1 Products affected

2 Type of change

Ground terminal assembled with a clamping plate.

9009					0118.2238	
creation date	created by	release date	released by	notification no.	revision	page
2014-08-20	bisanger	2014-08-22	bisanger	26278	-	1 of 2

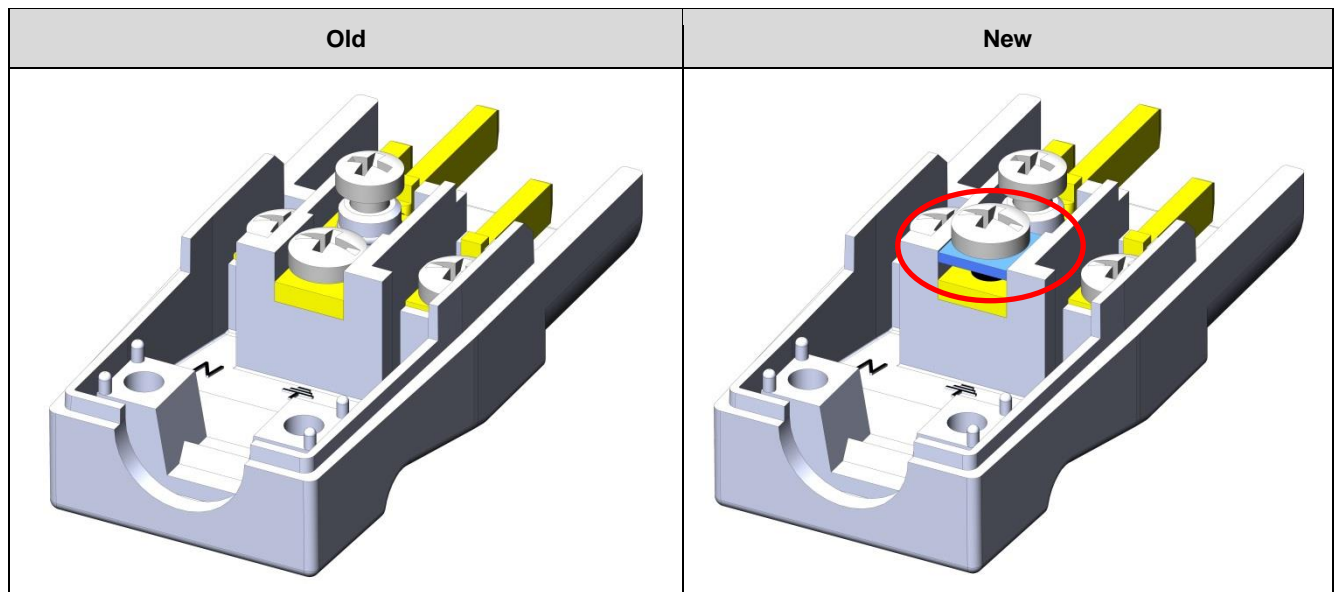
The terminal screw "Ground" is pre-assembled with a clamping plate, which will retain all individual wires below the screw head (blue part in picture below).

An uncareful wire insertion could lead to unsatisfactory screw connection. The clamping plate makes the handling easier and the screw connection more safe.

Form: N/A
Fit: Screw terminal "Ground" assembled with a clamping plate
Function: N/A
Production Site: N/A
Product Label: N/A
